REMARKS

Response to the Objection to the Drawings

FIGURE 4

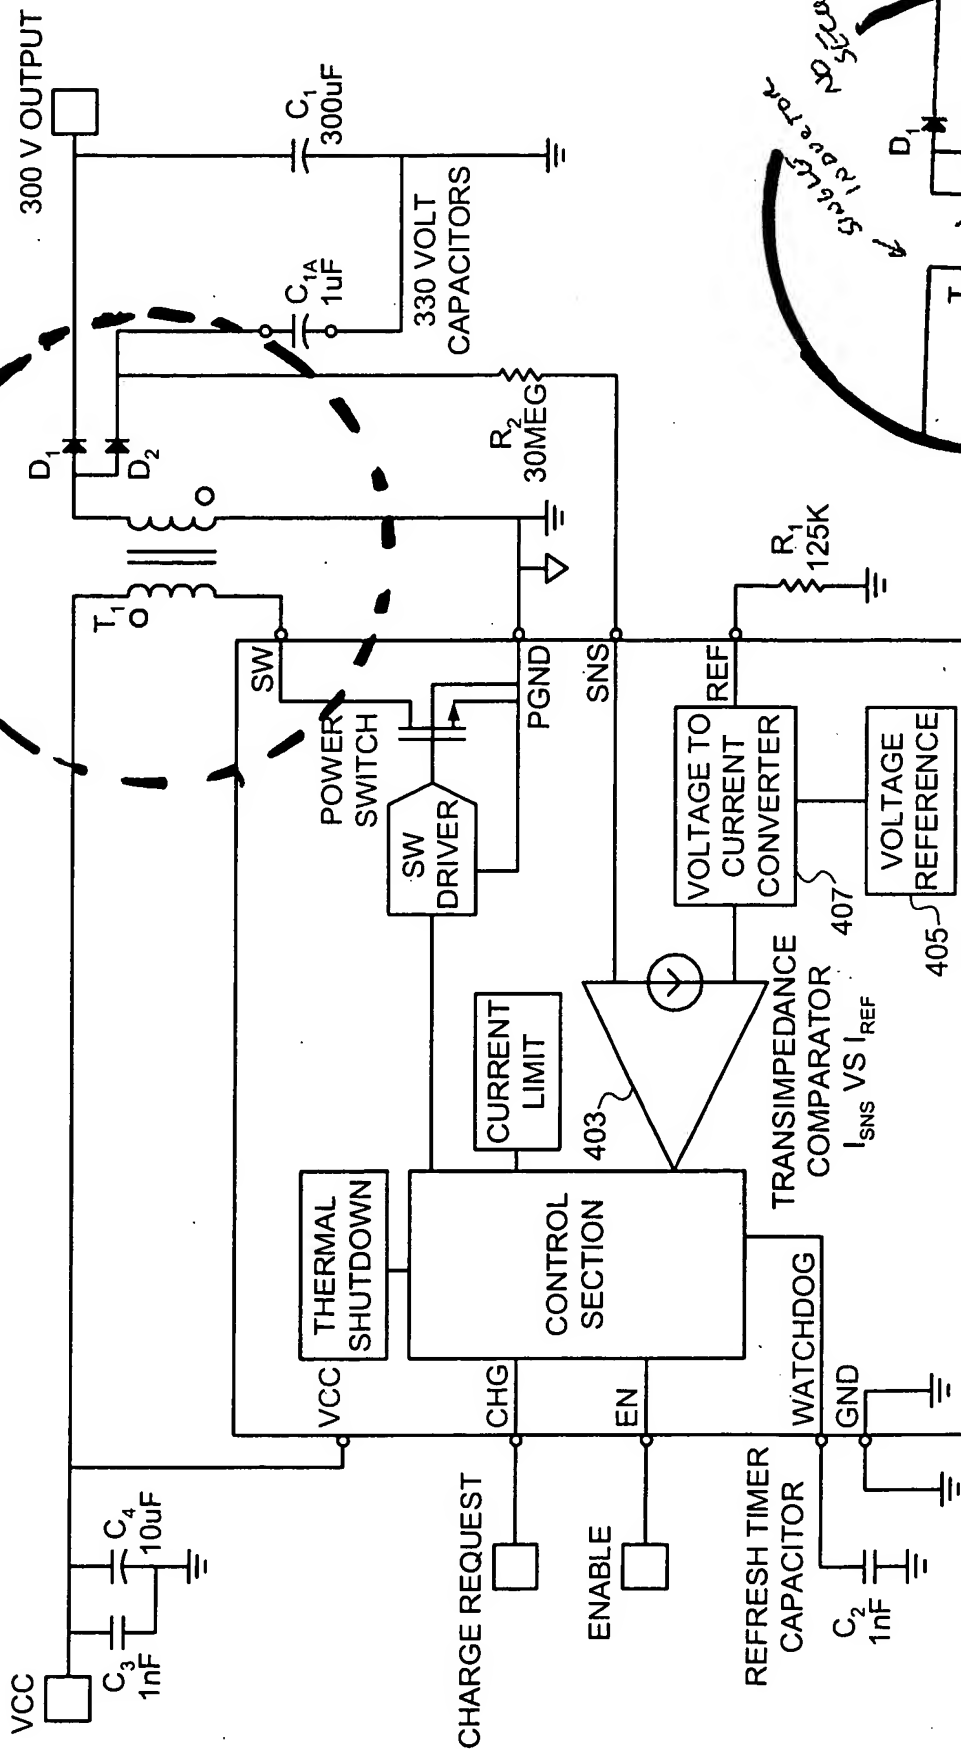
The drawings were objected to as failing to comply with 37 CFR 1.83(a) because the indicated inductive booster in claim 7 was not shown in the Figures. A new complete set of drawings marked "Replacement Sheet" as required by the Examiner, is provided with this response, in compliance with 37 CFR 1.121(d) and 1.84(c). The attached sheet(s) of drawings includes changes to Figure 4, in which the inductive booster providing the output of claim 7 is shown without entering any new matter.

The attached sheet(s) of drawings includes changes to Figure 4, in which the inductive booster providing the output recited in claim 7 is shown without entering any new matter, as per the Examiner's directive. In accordance with the Office's revised format, these drawings have each been labeled "Replacement Sheet".
